Bureau of Environmental Health

July 11, 2016

RE: Compromised replacement sand mound area

SITE PLAN
 SCALE: 1" = 40'-0"
 FEBRUARY 16, 2016

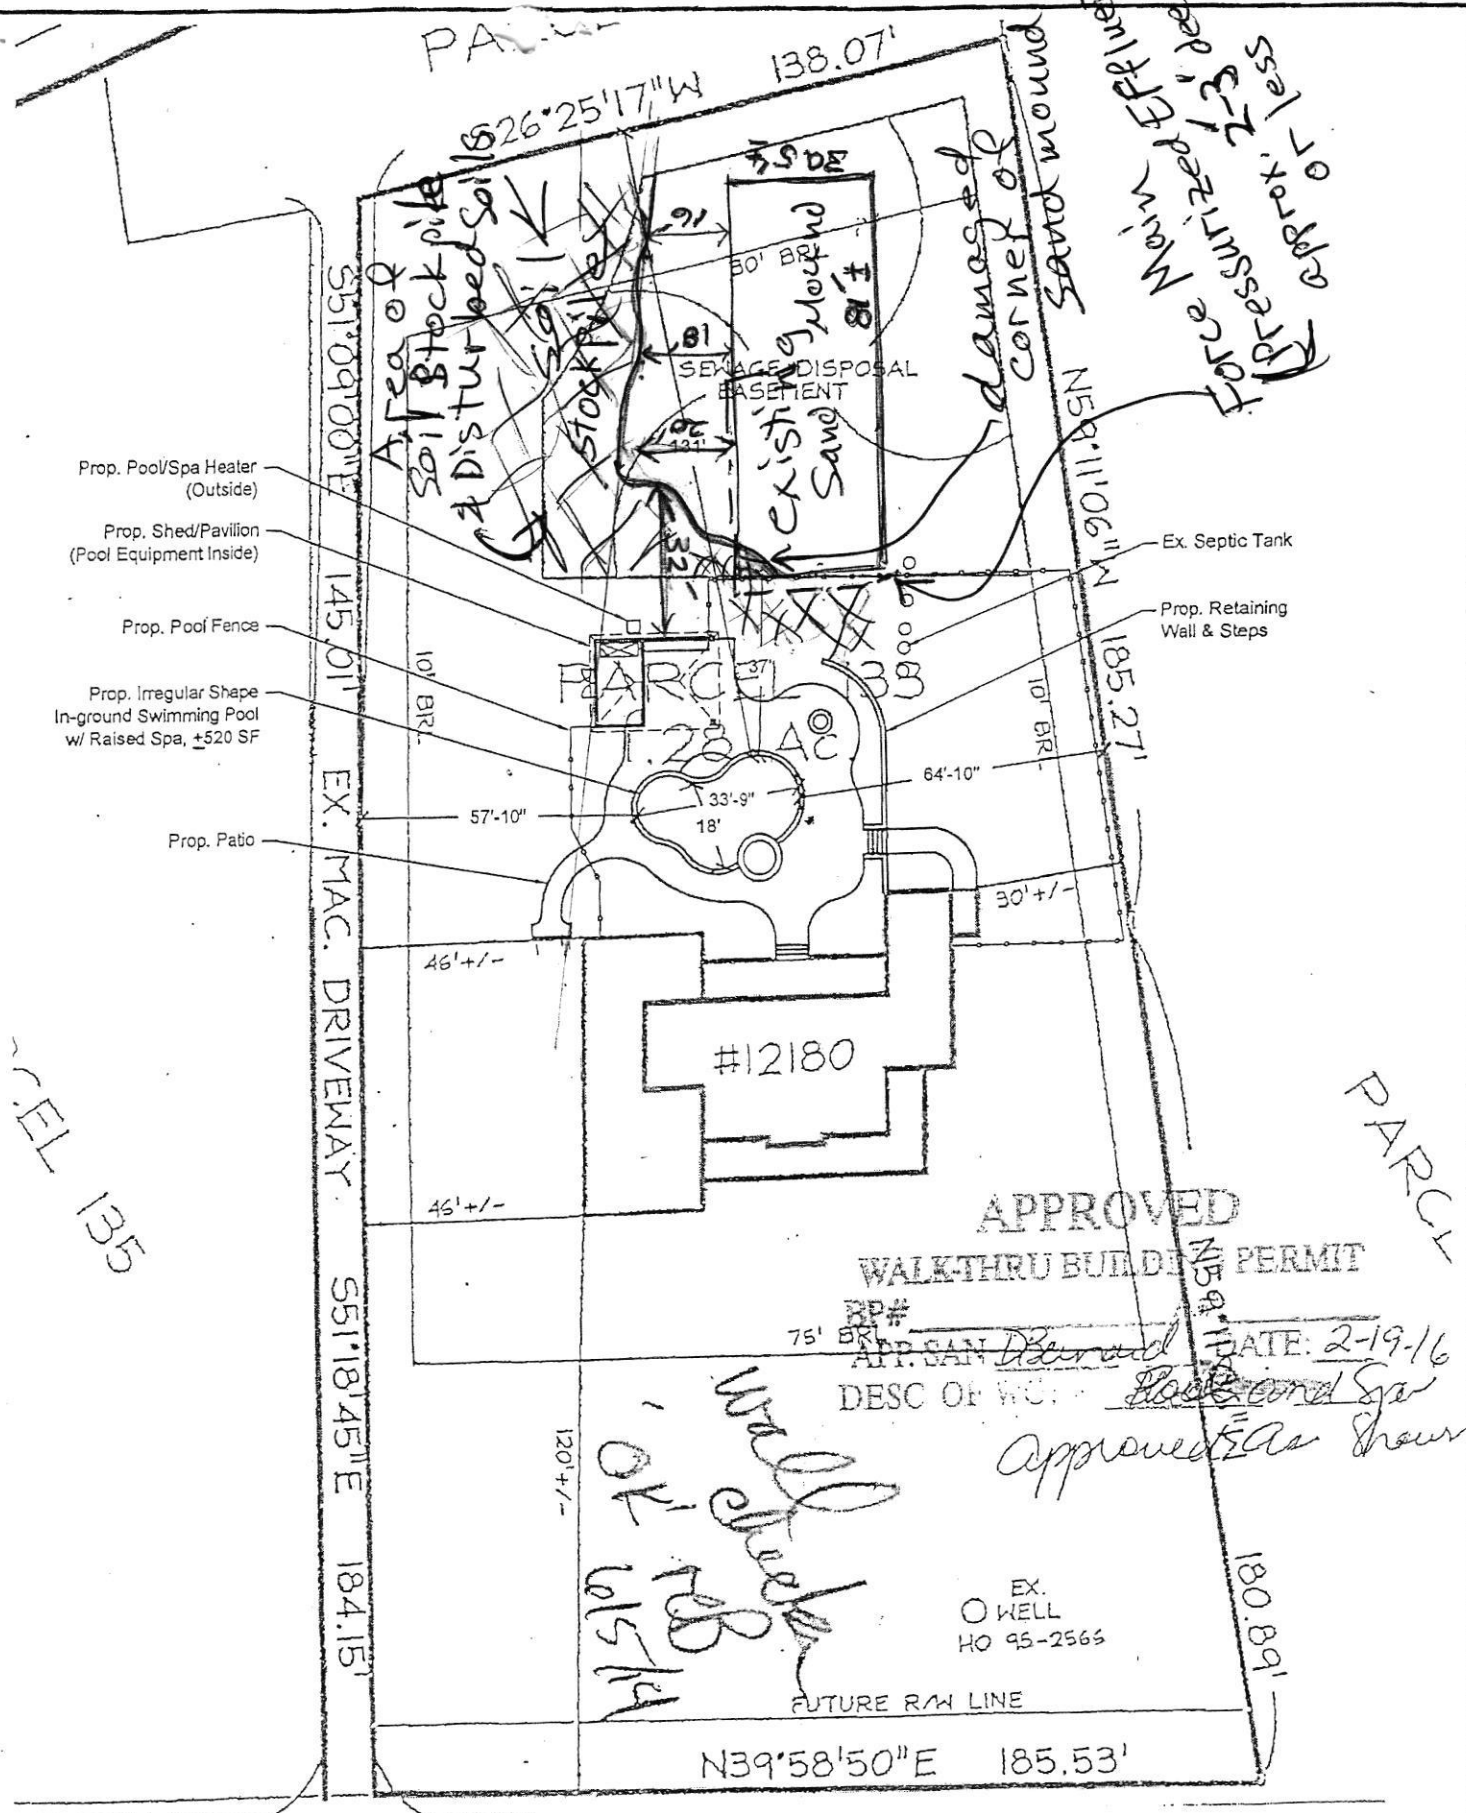
I found that the area designated for a replacement sand mound has been impacted by the operation of excavation equipment, and by the stockpile of soil. The weight of the soil stockpile is compacting the soil surface beneath it, an adverse condition for a potential sand mound area as the soil surface is the potential infiltrative surface. In the area immediately adjacent to the soil stockpile, there is evidence that soil has been removed by the excavator and that the exposed surface has been compacted as well.

The measured width of undisturbed soil between the existing sand mound and the disturbed soil ranges from 16-to-20 feet. The area of soil disturbance widens in proximity to the shed that is being constructed. I measured a distance of 32 feet from the back of the shed to the edge of the exposed soil surface. Attached is a graphic on which is illustrated the impacted portion of the Sewage Disposal Area (SDA) which is labeled as "Sewage Disposal Easement" on the drawing.

In addition to the impact on the area for the replacement sand mound, I found that the corner of the existing sand mound has been partly excavated, and the soil surface in the area where a pressurized wastewater effluent pipe is buried has been excavated. Potential damage of the buried pipe could not be determined at the time of the evaluation.

It is very important that no additional damage occurs to the area designated for future wastewater disposal. Therefore, these are actions you need to implement immediately to protect that area:
